Addendum #2

Date: December 17, 2025

Subject: Addendum #2
H&P Project # 2025087
Seneca Park Phase 1 Water & Sewer
Campbell County, VA

HURT & PROFFITT
INSPIRED / RESPONSIVE / TRUSTED

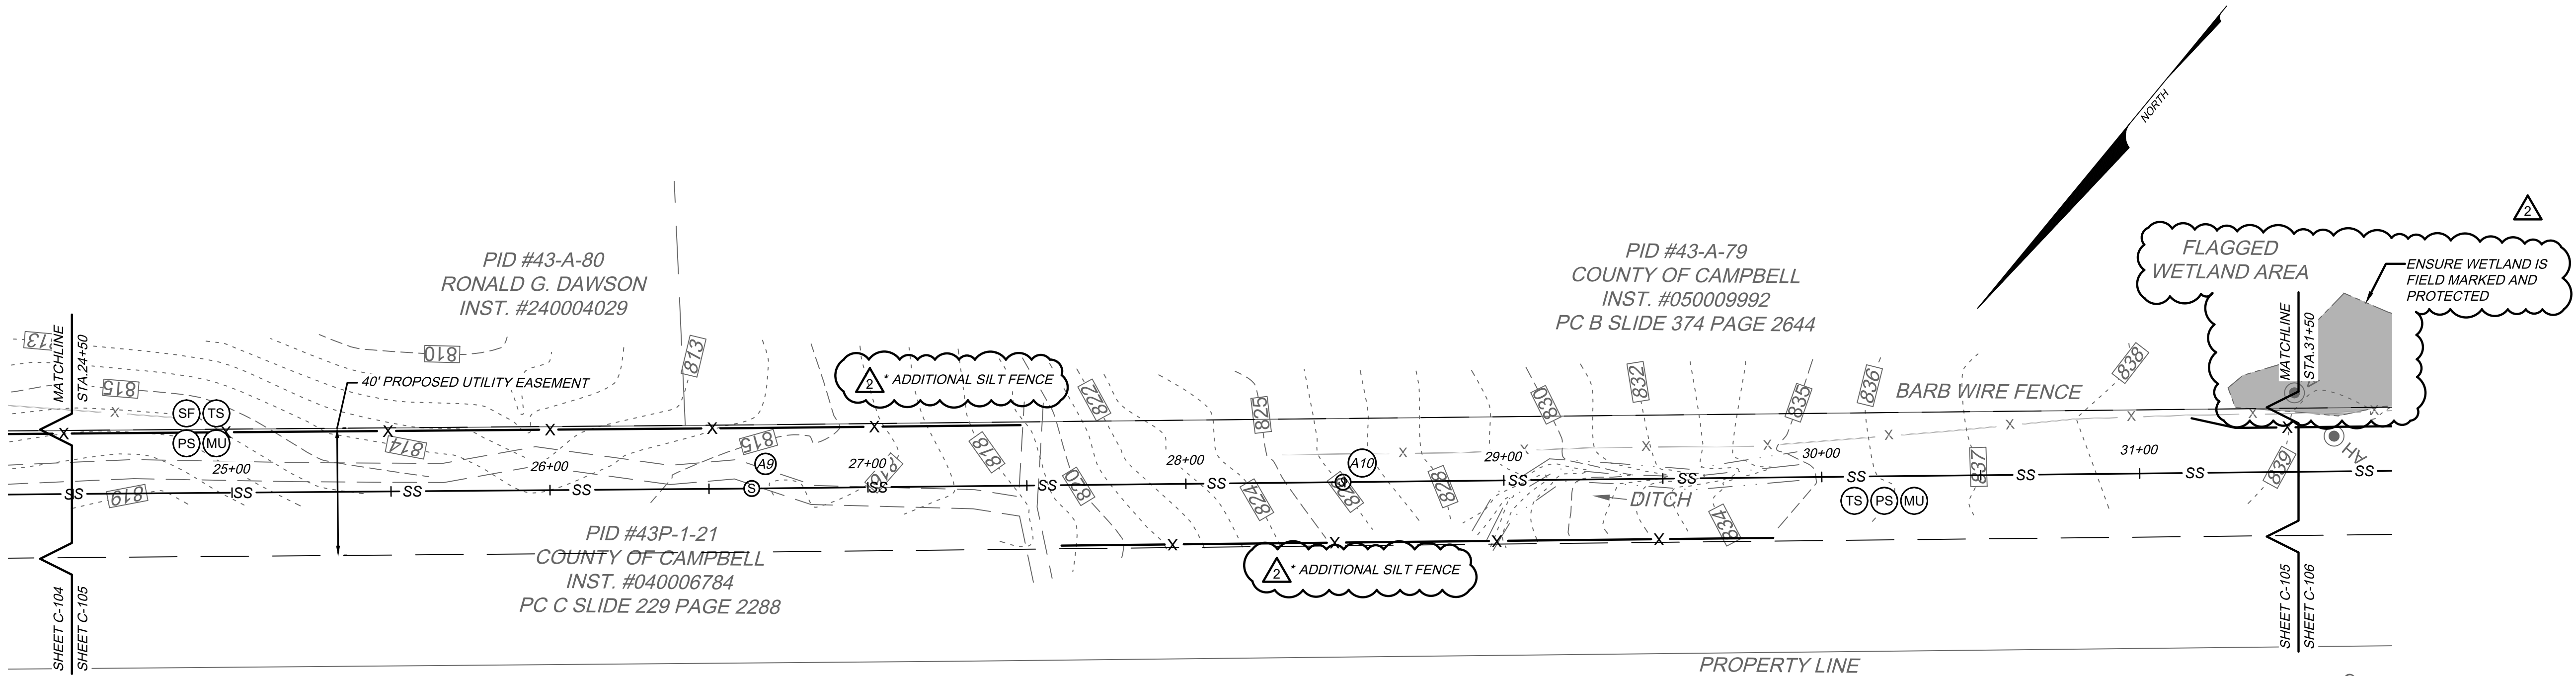
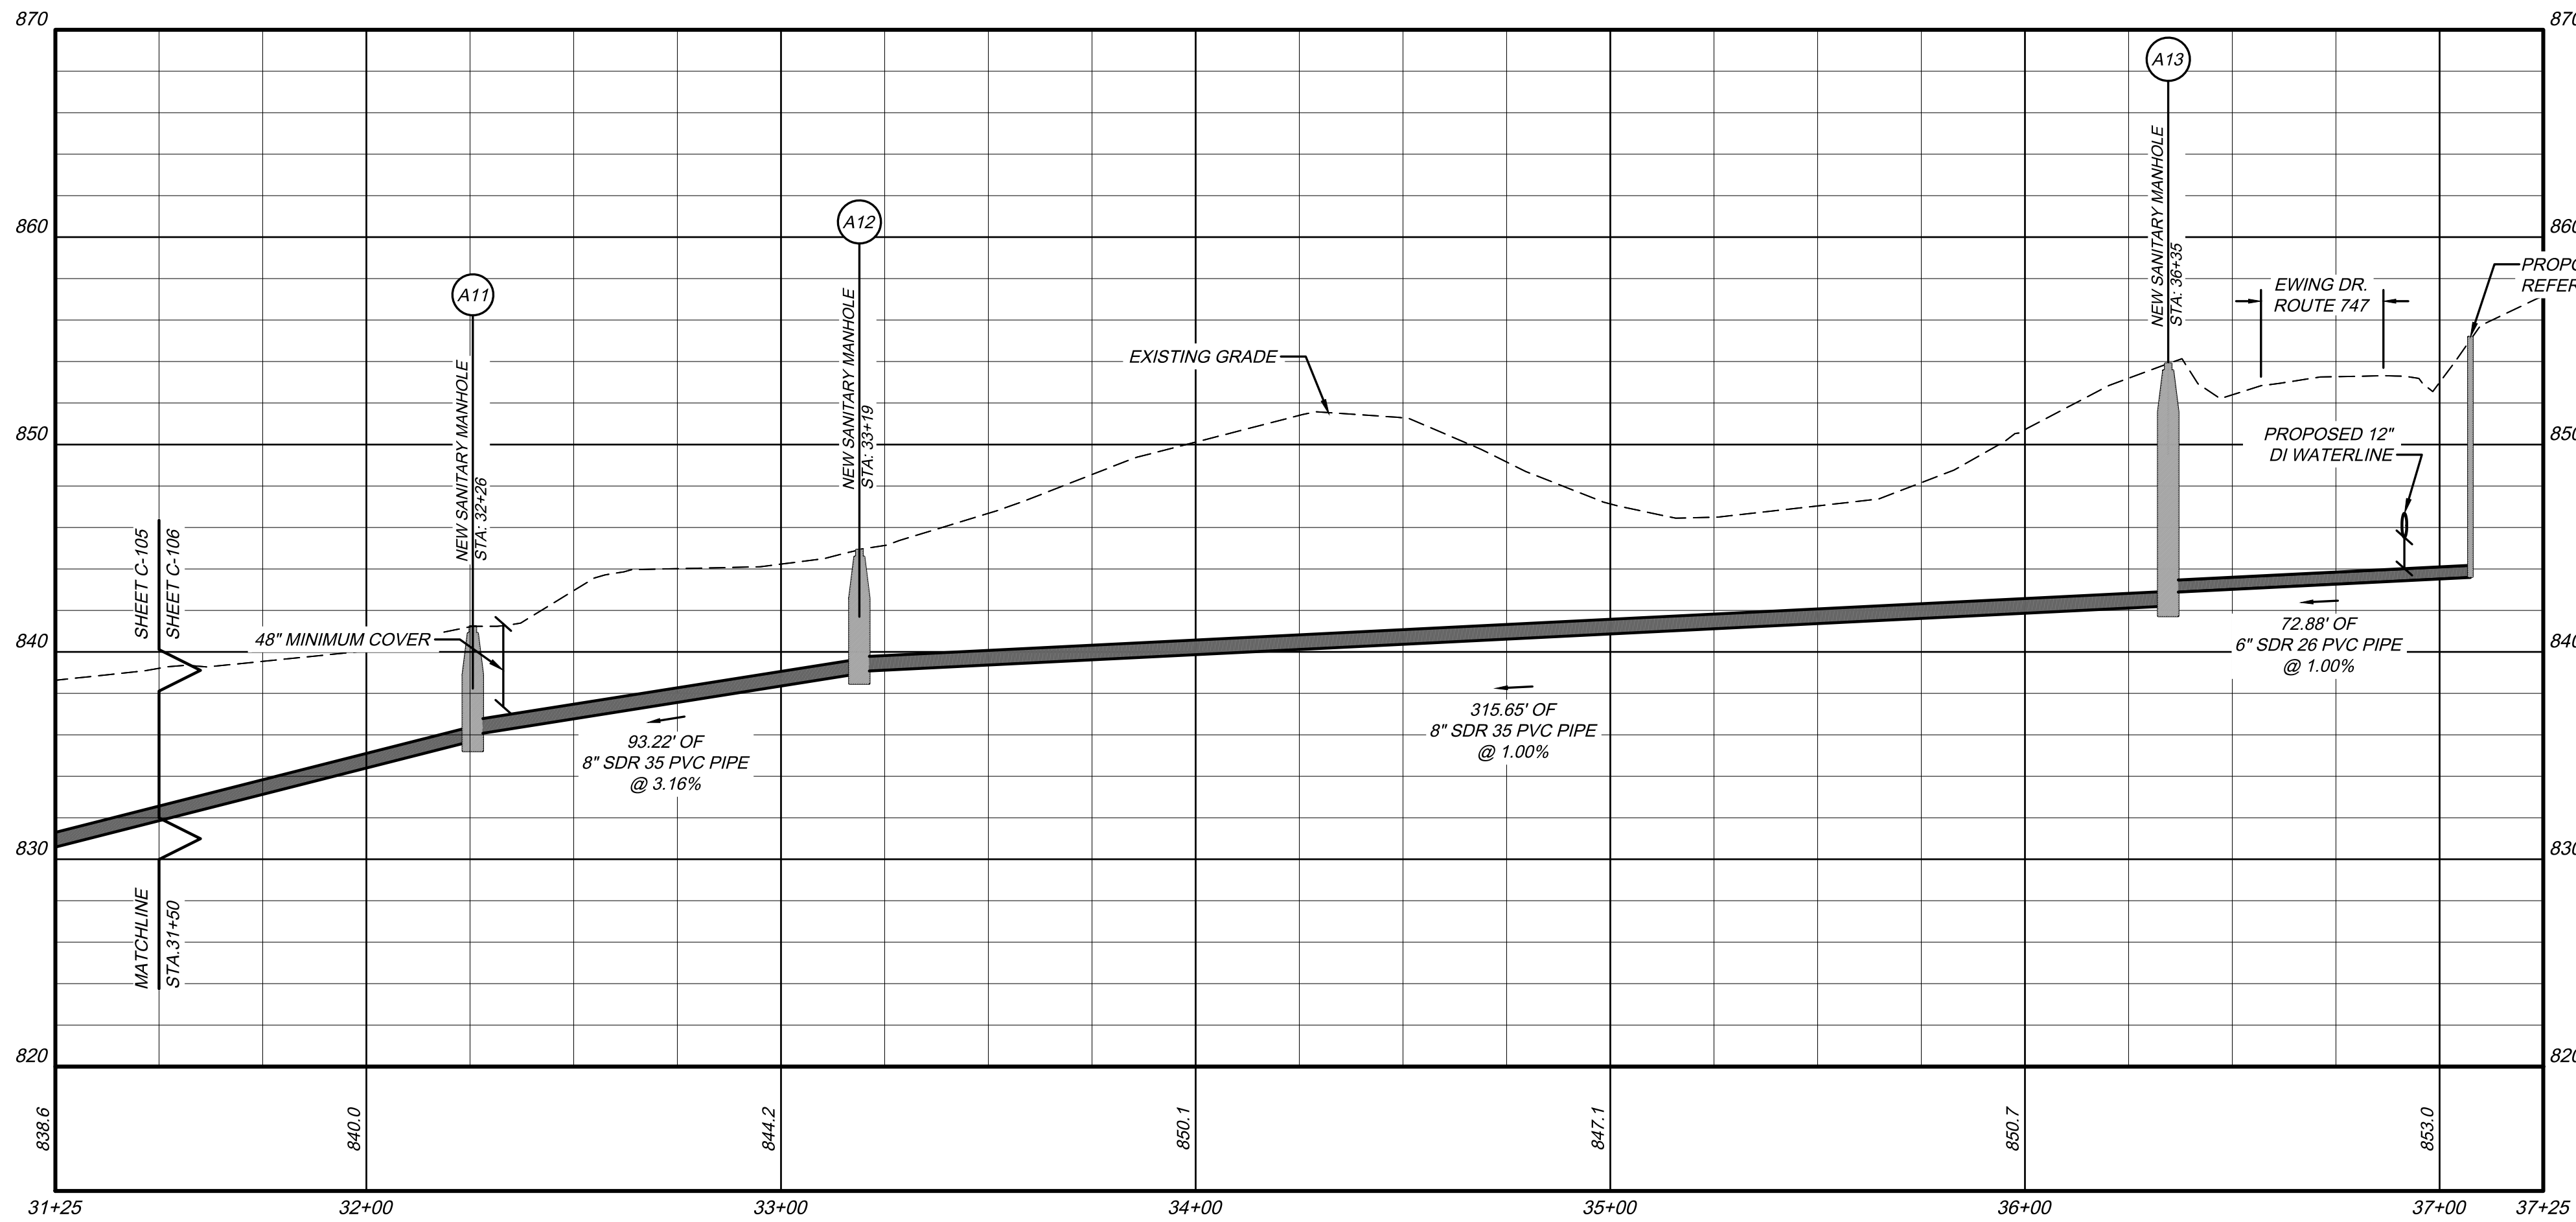
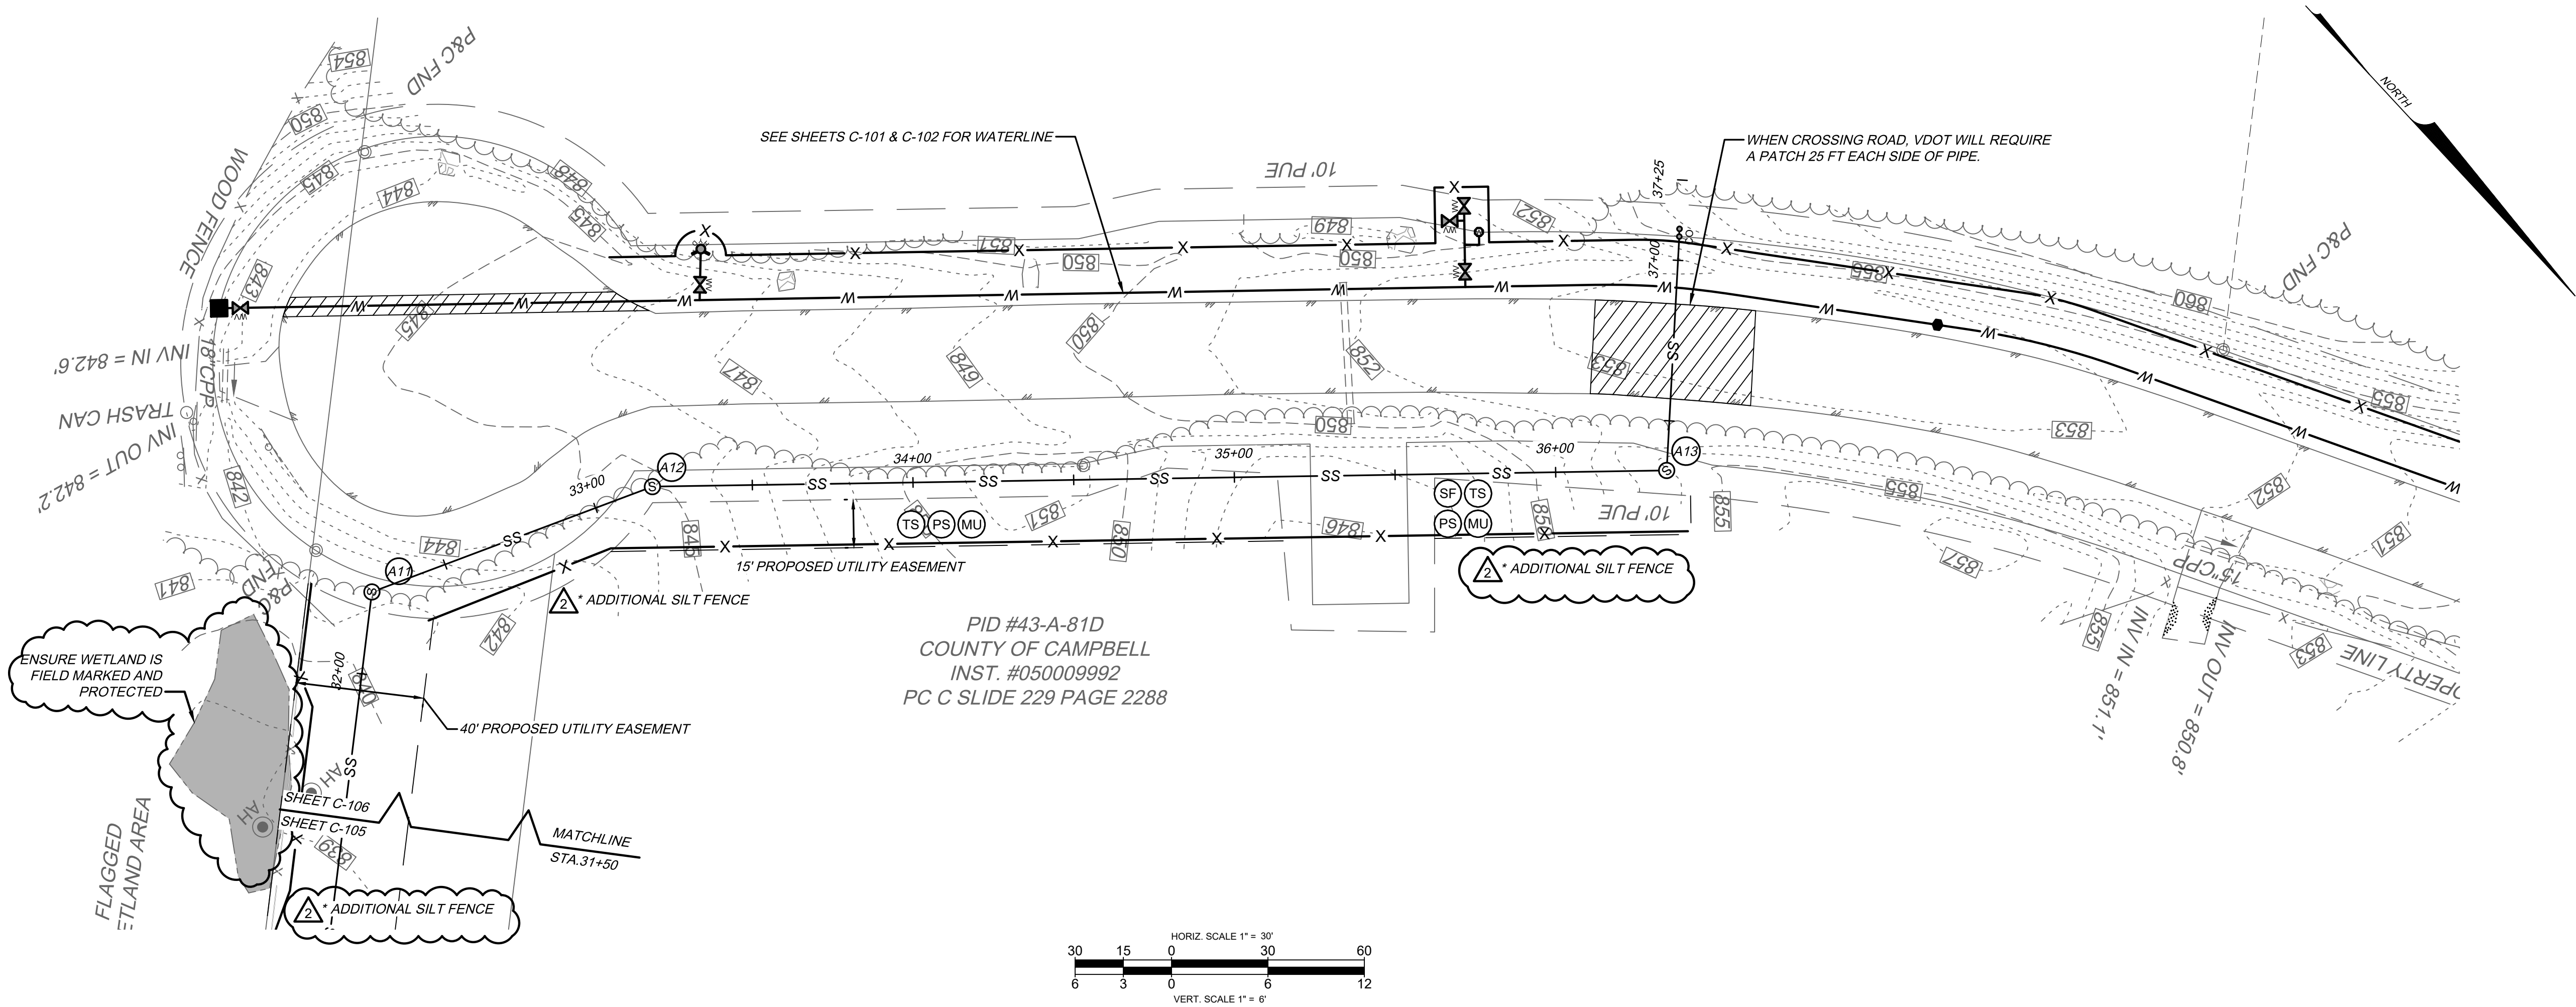
Item Ten: Silt Fence

Silt fence lengths have been updated on the plans based on County comments. The updated quantity has been revised on the bid form.

Updated plan and profile sheets will be included with this Addendum to show the added silt fence and updated water line structure. All changes will be clouded.
